MANITOWOC SERVICE BULLETIN W08-010

DATE: 07-25-2008

SUBJECT: Model 16000 #58 boom sections, #59A mast sections and #59 Luffing jib sections

MODEL AFFECTED: 16000

FIGURE 1

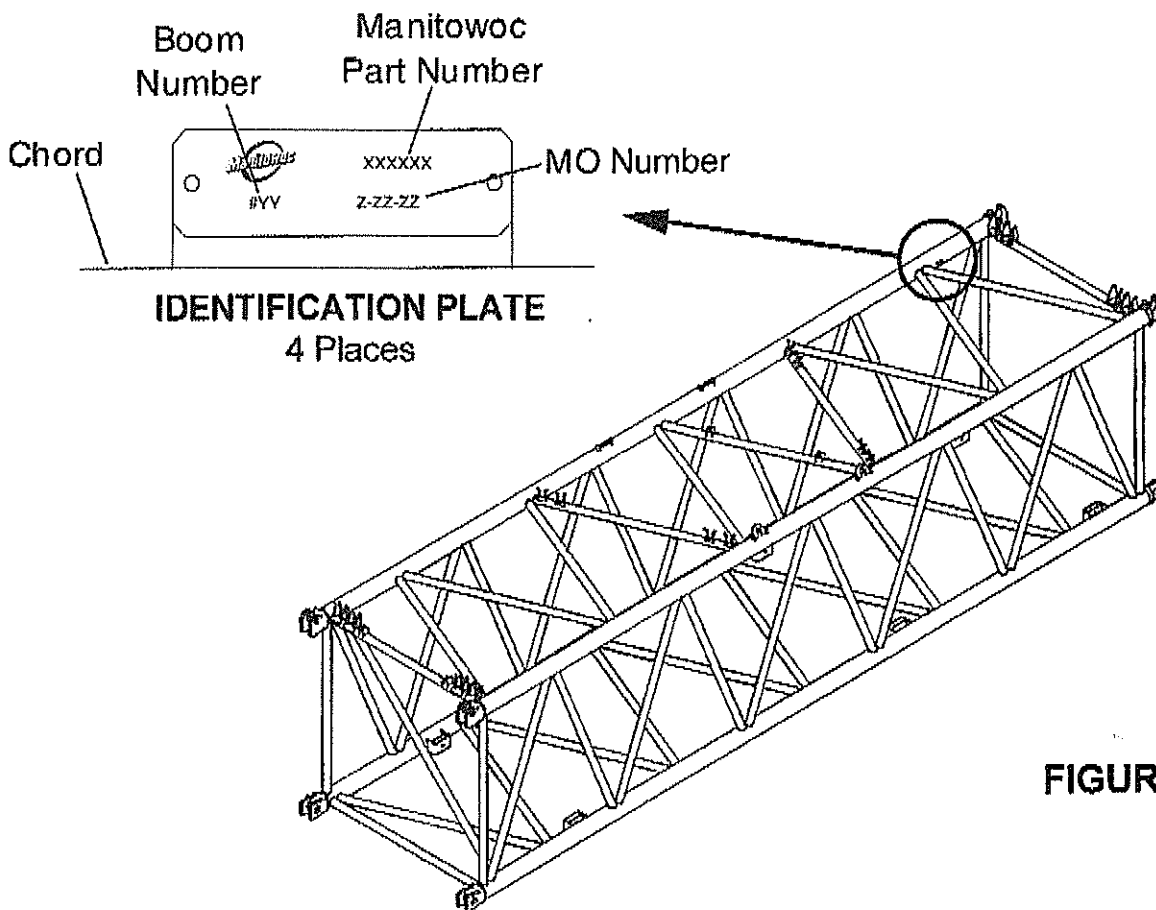
The weldments identified in the table below may have chords which do not comply with the specified wall thickness. The weldment part numbers appear on the identification tag on each boom, mast or jib section as shown in Figure 1 below. The corresponding section assembly numbers for these weldments are also provided for reference.

If a weldment part number matches one of those listed above, locate the manufacturing order (MO) number on the identification tag for the weldment as shown in Figure 1 and compare it to the MO numbers listed on the attached Inspection Report. If the MO numbers for any of the weldments match the MO numbers listed in the Inspection Report, ultrasonic test the weldment in accordance with Section A3 below. If you need assistance in locating ultrasonic test equipment or ultrasonic testers, please contact the Crane CARE Lattice Team at **1-888-499-7278** for further instructions.

- a. Lower #58 boom, #59 luffing jib or #59A mast so the top is resting on ground or blocking.
- b. Prior to inspection procedure verify that the weldment part number and (MO) on the identification plate located as shown on Figure 1 matches the weldment part number and manufacturing order number (MO) listed on the attached Inspection Report attached to the Bulletin.
